In the Drawings:

Please replace drawing sheets 3-4 (showing Figs. 2d-2i) with the newly submitted figures attached herewith on separate sheets.

Amendment to the Specification and Drawings

FIG. 2e

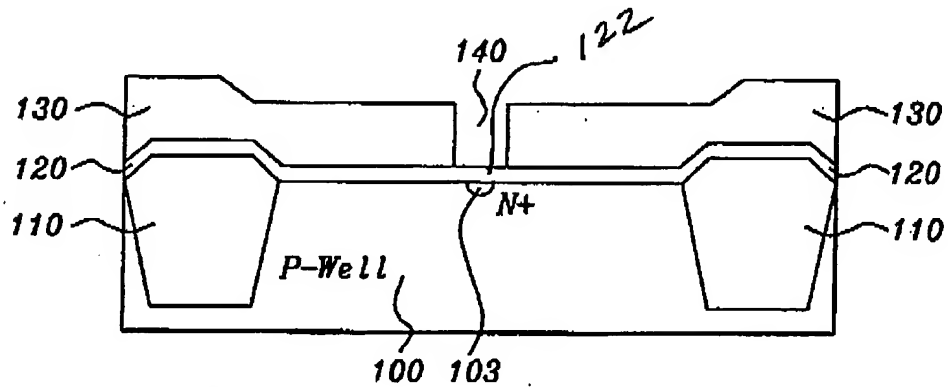
Applicants have amended the specification to change reference numeral 120 to 122, at the bottom of page 14. Applicants also insert, in Figs. 2e-2h, a symbol of 122 to indicate a tunnel oxide and accordingly amends the specification in pertinent part. These amendments add no new matter to the present application.
